Access Compliance Report

Public Rights-of-Way

Intersection ID: 5421	Main Street: SUNSET_RD	Cross Street: OLD_STATESVILLE_RD	Location: E
ADA ID: C58FCEFD6F3C	Ramp Type: Perp	Initial Pass/Fail: Fail	Overall Compliance: No
		Severity Score: 12.5

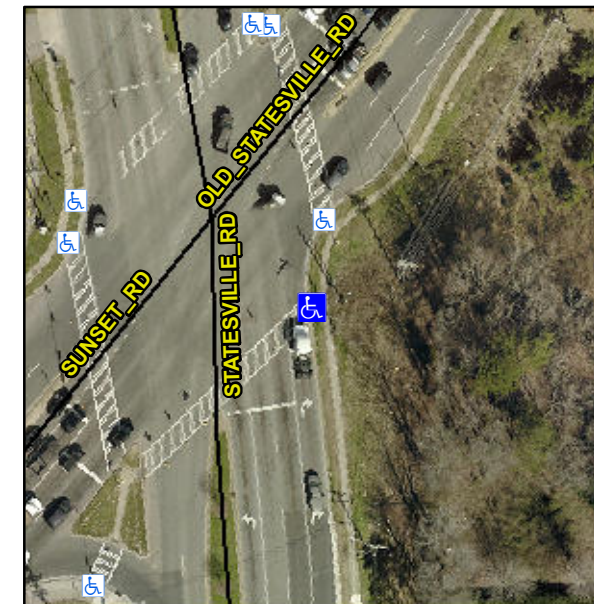
Not Found, R304.2.2

Compliance	Description	Data	Compliance	Description	Data
N/A	Ramp Length (in)	60.0	No	Ramp Slope (%)	10.6
Yes	Ramp Width (in)	48.0	Yes	Ramp XSlope (%)	0.4
N/A	Flare Type LT	N/A	N/A	Flare Type RT	N/A
N/A	Flare Slope LT (%)	N/A	N/A	Flare Slope RT (%)	N/A
N/A	Flare Traversable LT?	N/A	N/A	Flare Traversable RT?	N/A
N/A	Landing Length (in)	N/A	N/A	DWS Provided?	N/A
N/A	Landing Width (in)	N/A	N/A	DWS Contrast?	N/A
N/A	Landing Slope (%)	N/A	N/A	DWS Length (in)	N/A
N/A	Landing X Slope (%)	N/A	N/A	DWS Full Width?	N/A
N/A	Landing Curb? (Y/N)	N/A	N/A	DWS Offset (in)	N/A
N/A	Shared Landing?	N/A			
N/A	Gutter Ponding?	N/A	N/A	Gutter Slope (%)	N/A
N/A	Gutter Lip Ht (in)	N/A	N/A	Gutter X Slope (%)	N/A
N/A	Painted X Walk1?	Yes	N/A	Painted X Walk2?	N/A
	X Walk 1 Direction	To SW		X Walk 2 Direction	N/A
N/A	X Walk 1 Width (in)	142.0	N/A	X Walk 2 Width (in)	N/A
	X Walk 1 Slope (%)	3.7		X Walk 2 Slope (%)	N/A
	X Walk 1 X Slope (%)	2.2		X Walk 2 X Slope (%)	N/A

Remove & Replace Entire Ramp.
